Responses to Resident Submission Letter

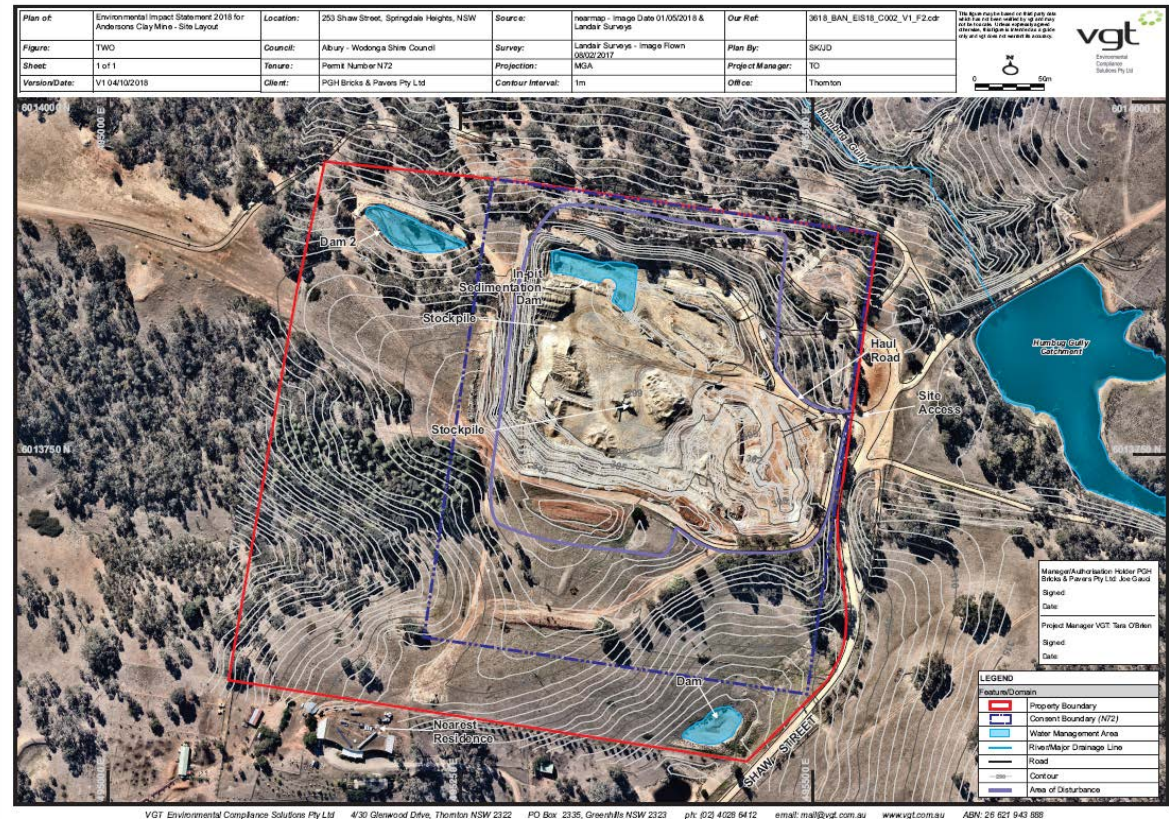
Item	How Addressed
<p>Paragraph 2</p> <p><i>We note in the EIS that PGH conducted a letter drop in May 2018 which we are aware of, and that they did not receive a response from us. The letter drop did not make any mention of the southern expansion. The text of the letter and the associated map only depicted the north western proposed Expansion Area. Discussions with Council during our own development planning stages and subsequent discussion with mine excavator operators over the ensuing years only referenced the north western expansion. It is this new southern expansion as only detailed in the EIS that does concern us.</i></p>	<p>Mining to the south is currently consented as per N72. The consented area is outlined in the plans attached to the consent as shown below.</p>  <p>In addition the Council has provided correspondence dated 11/9/2001 that determines the pit dimensions as 274m by 330m.</p> <p>The Planning Certificate for the residents land to the south (Lot 1 DP838710) states any development of the site must consider relevant State Environmental Planning Policies as listed in the Appendix B of the Planning Certificate. Appendix B lists SEPP (Mining, Petroleum Production and Extractive Industries (2007) as a planning instrument that must be considered. Principally, the mine was in existence prior to the construction of the dwelling in Lot 1 DP838710 and the potential impacts on any development should have been considered prior to construction. Given the consent boundaries of the mine, it would be reasonable to assume that mining could progress to the south up to the buffer limit of 15 metres.</p>

Item	How Addressed
	<div data-bbox="837 212 1608 775" data-label="Image"> <p>18</p> <p>REFERENCE: 30906 RG: mv CONTACT: [REDACTED] 0011006883</p> <p>11 September 2001</p> <p>[REDACTED] Boral Bricks Pty Ltd PO Box 507 LAVINGTON NSW 2641</p> <p>Dear Gary</p> <p>SUBJECT: <u>721 SHAW STREET, SPRINGDALE HEIGHTS</u></p> <p>I refer to your enquiry regarding boundaries relating to Anderson's Pit located with the abovementioned property.</p> <p>Perusal of Council's files indicates that:</p> <ul style="list-style-type: none"> a) The Development Consent (No. N72) boundary for the pit has dimensions, 274m by 330m. b) The title boundary of Lot 2 DP856969 which contains the pit has, approximate dimensions 399m x 375m. <p>ALBURY City of Excellence</p> </div> <p>These dimensions have been depicted in the VGT figures in the EIS as shown below.</p>

The consent condition 13 i) clearly states that the only area excluded from extraction is a 15m buffer from the boundary of the permit area.
